EAGLE RANCH ROAD, N.W.

CHANGE ORDER NO. 7

SHEETS 1,4,5,6,7,8,9,10,11

The above-mentioned sheets are temporary additions to the final plans for Eagle Ranch Road. They outline the paving plan for completing approximately one half of the road as directed by the owner. Upon completion of the entire road section, these sheets shall be replaced by the originals.

N.M. Utilities	<i>[Signature]</i>	7/6/85									
DRAWING NO.	2440	MAP NO.	C-13	SHEET	11	OF	16

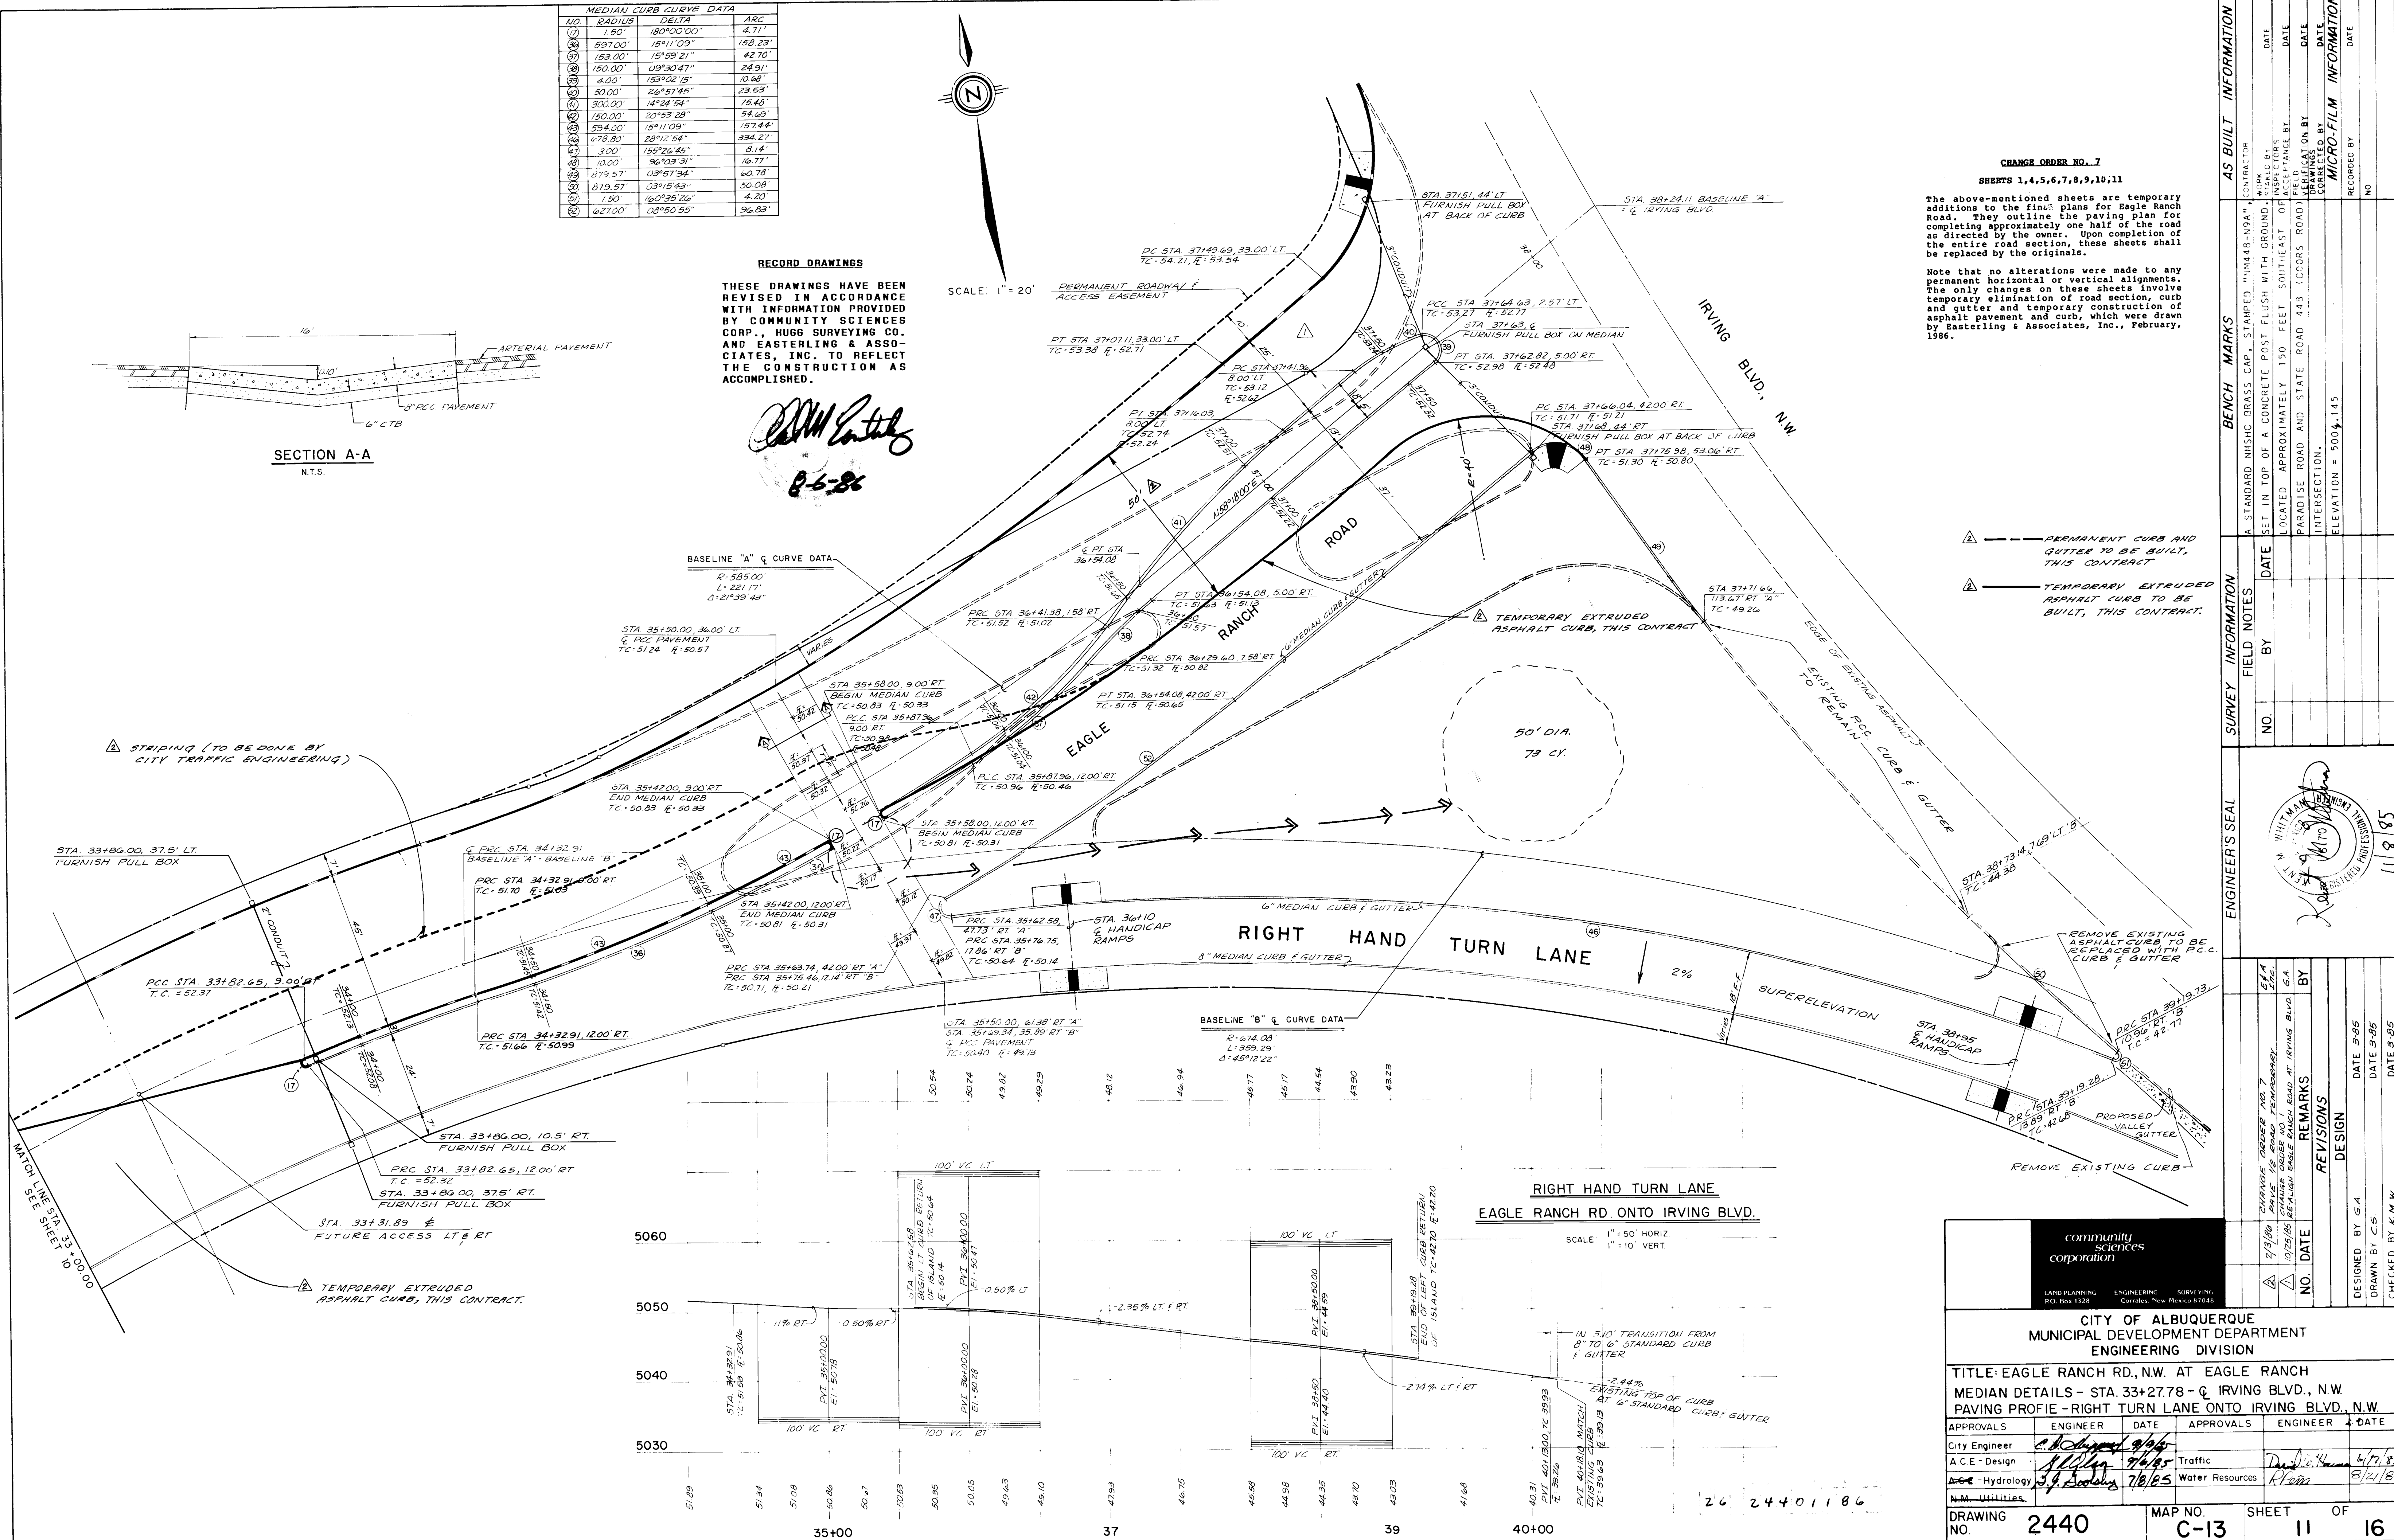
The above-mentioned sheets are temporary additions to the final plans for Eagle Ranch Road. They outline the paving plan for completing approximately one half of the road as directed by the owner. Upon completion of the entire road section, these sheets shall be replaced by the originals.

Note that no alterations were made to any permanent horizontal or vertical alignments. The only changes on these sheets involve temporary elimination of road section, curb and gutter and temporary construction of asphalt pavement and curb, which were drawn by Easterling & Associates, Inc., February, 1986.

- PERMANENT CURB AND GUTTER TO BE BUILT, THIS CONTRACT
- TEMPORARY EXTRUDED ASPHALT CURB TO BE BUILT, THIS CONTRACT
